Tree warden notes on planning application (outline) for Japonica Cottage

The application for outline permission for a house with parking spaces and turning area has a number of problems.

Visibility splay

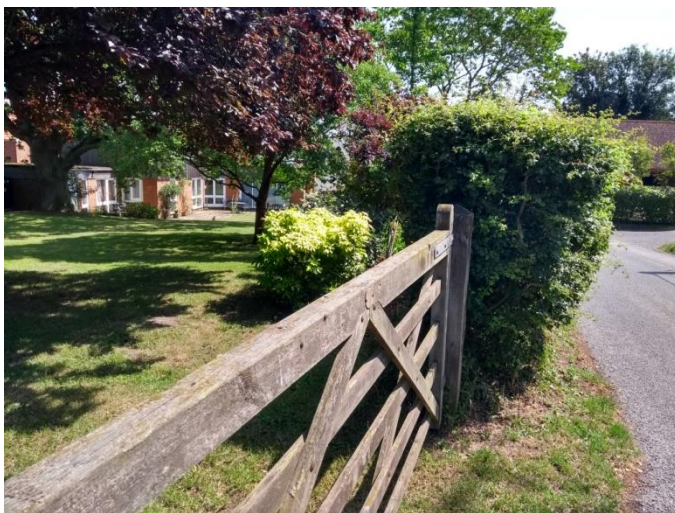
The visibility splay shown here involves the removal of all of the good hawthorn hedge fronting the road which is about a 12m length. Cliff Road leading to the river is part of the character of the village with hedges either side although unfortunately some have been replaced with fencing.

The arboricultural report does not appear to mention the loss of the hedge although it is shown on the plans.

As well as the long stretch of hedge down to where it meets a wall, a piece between the proposed entrance and Dormers next door would also be removed.

It is a difficult exit onto the road. However, many houses in the village have similar exits. We have to reverse into ours always.

If everyone had this sort of visibility splay there would be no hedges – or fences – in the village! There is a 20mph limit. Perhaps a mirror would be possible?
